**CITY OF MADISON
INTERDEPARTMENTAL
CORRESPONDENCE**

Subject: 666 Wisconsin Avenue

Proposed Use: Renovate existing hotel, modify existing hotel, and construct an 8 story hotel addition.
Waterfront Development Conditional Use.

1. **15483** Edgewater Redevelopment - 666 Wisconsin Avenue - Mansion Hill Local Historic District.

12 Langdon St.

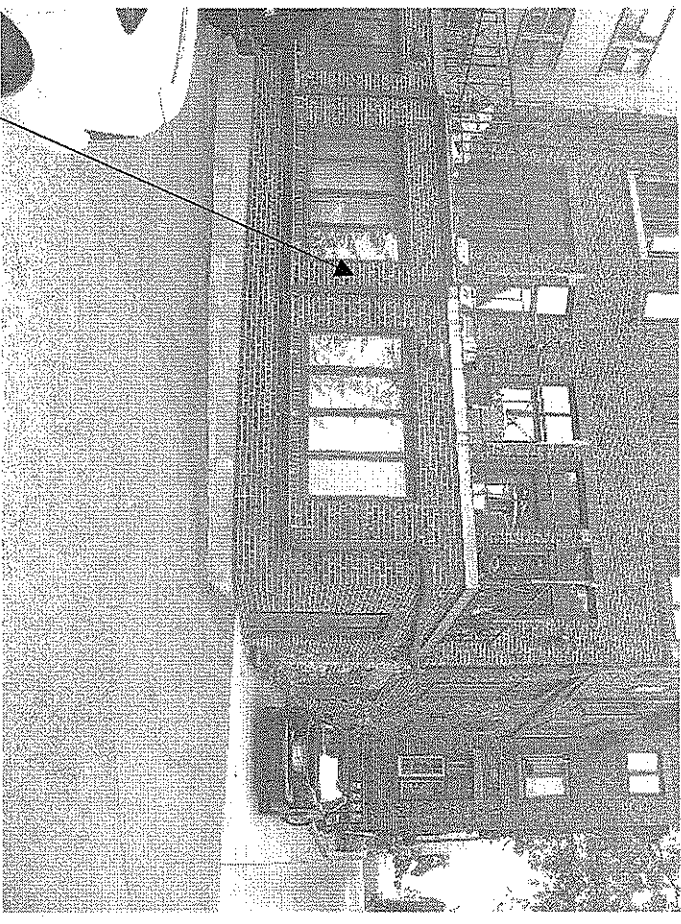
1. When we met previously to discuss this issue, there was some question as to what portion of the buildings you should measure to for 12 and 28 Langdon Street. I recall that your group wanted to measure to a retaining wall for a surface parking lot at 12 Langdon St., and also wanted to measure to an at-grade patio for 28 Langdon St. I had indicated at that time that you could not measure to those features, you needed to measure to the buildings and other qualifying portions of the buildings (please see the attached pictures specifically showing where to measure to). In looking at the aerial photo accompanying the submittal, it looks like you measured to the parking lot and surface patio, and not the qualifying portions of the buildings. I see in your submittal, beneath Table 1, you provide a general statement describing the measurement. For clarification purposes, would you please identify where you measured to for 12 and 28 Langdon Street, or a survey showing the features you have measured to?

Measure to this
wall of bldg

28 Langdon St.

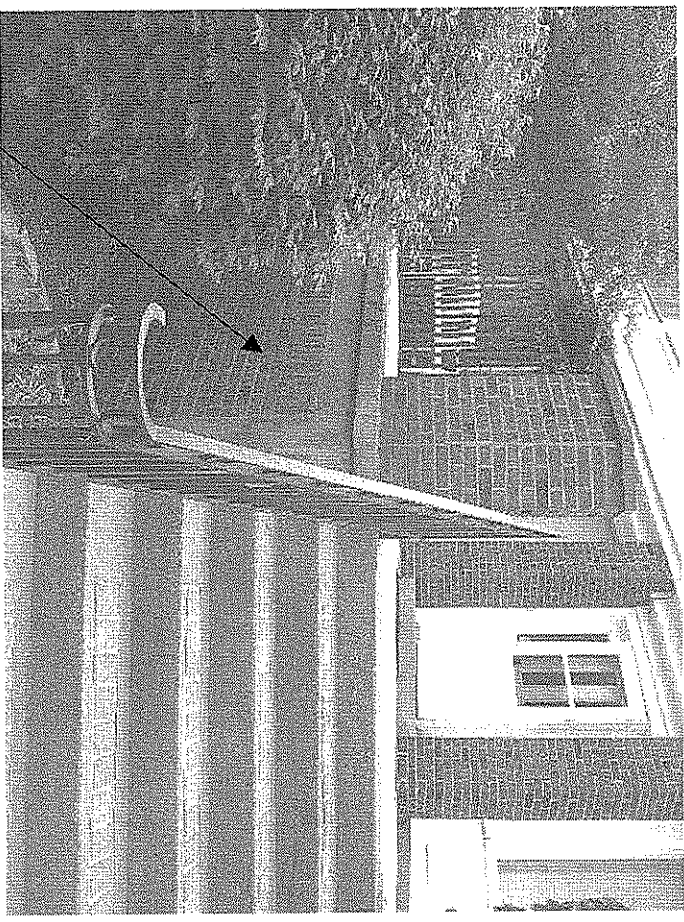
Measure to the
edge of this
elevated patio
